# **SPRC** March 20, 2023

#### SPLN22-00006 Arva Motel (Days Inn)

General Land Use Plan Amendment, Rezoning, New Site Plan

2201 Arlington Boulevard (RPC#18-059-020)

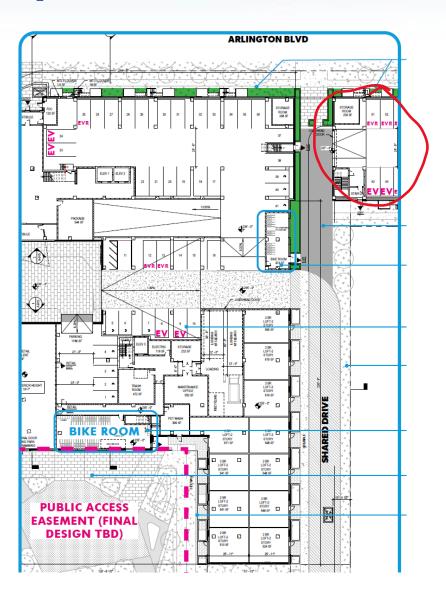
### Staff Issues

- Above grade parking;
- Transformer location;
- Suggest improved landscaping, esp. at southern end;
- Please provide evidence that the existing sign and lobby cannot be preserved;
- Can more be done for sustainability and biophilia at site?
